Comments and questions from  
Laurie and Alain Brion  
358 Viewcrest Road  
Bellingham 360 389-8032, 360 224-7348

## **JONES PROPOSED HOUSING DEVELOPMENT PROJECT**

"Photo of bedrock cliff showing evidence of 'toppling' of blocks that failed along jointing planes."

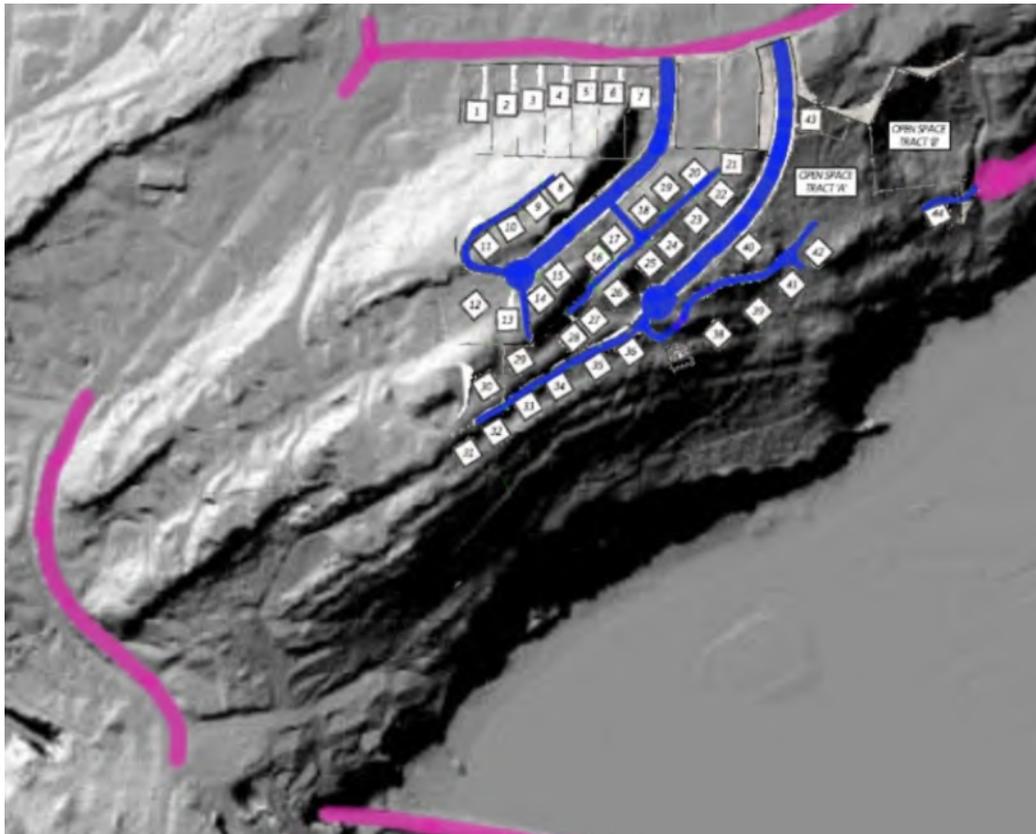
- 1) **EARTH**: Regarding the Earth element, the December 31, 2009 *Geologic Feasibility Investigation* prepared by Pacific Surveying & Engineering (PSE) concluded that:
  - a. In summary, geologic hazards at the site exist and include landslide, erosion and seismic hazards.

- b. [T]he subject property contains areas with steep topography and development will have to consider site-specific engineering designs and mitigative measures for portions of the property.

- c. Future development of the site could impact the current hydrologic condition... Changes in hydrology can alter the probability, frequency and magnitude of mass wasting (landslide) activity.

- h. Because of the steep slopes and existing groundwater conditions, modifications of groundwater or surface water flow may impact the potential size and frequency of mass wasting [landslide] events. The fine-grained soils found on site are susceptible to soil erosion resulting from the movement of heavy equipment or site grading.

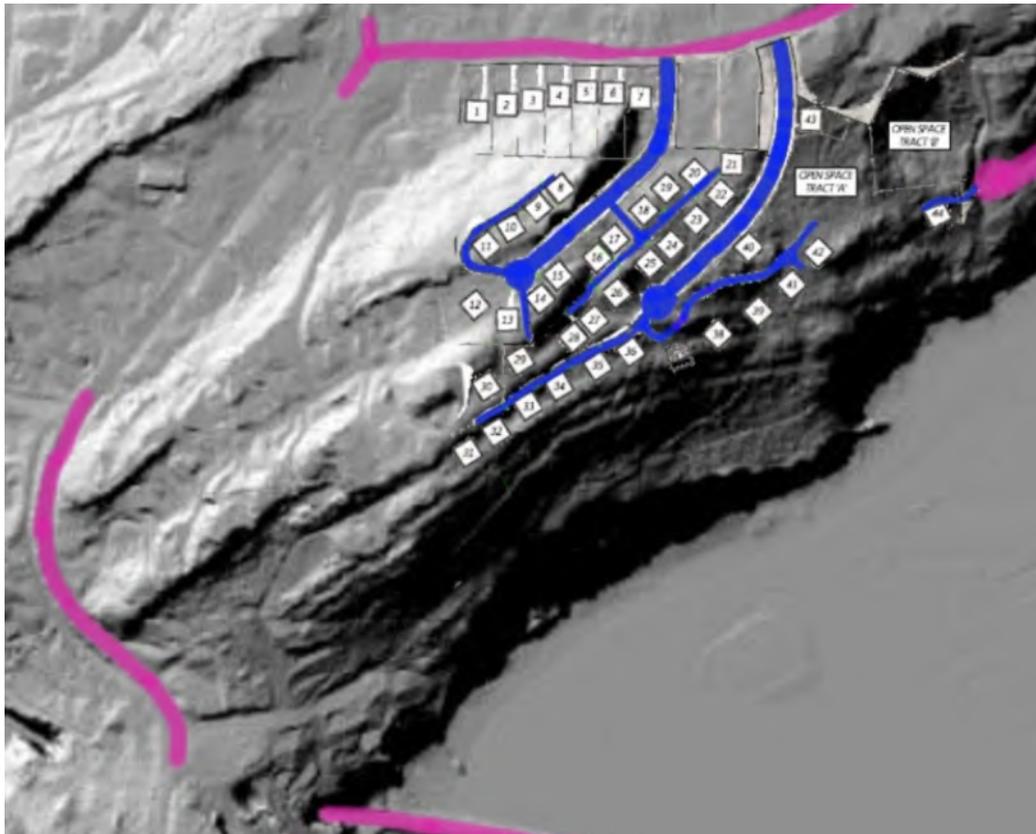
- 1) **EARTH**: Regarding the Earth element, the December 31, 2009 *Geologic Feasibility Investigation* prepared by Pacific Surveying & Engineering (PSE) concluded that:
  - a. In summary, geologic hazards at the site exist and include landslide, erosion and seismic hazards.

- b. [T]he subject property contains areas with steep topography and development will have to consider site-specific engineering designs and mitigative measures for portions of the property.

- c. Future development of the site could impact the current hydrologic condition... Changes in hydrology can alter the probability, frequency and magnitude of mass wasting (landslide) activity.

- h. Because of the steep slopes and existing groundwater conditions, modifications of groundwater or surface water flow may impact the potential size and frequency of mass wasting [landslide] events. The fine-grained soils found on site are susceptible to soil erosion resulting from the movement of heavy equipment or site grading.
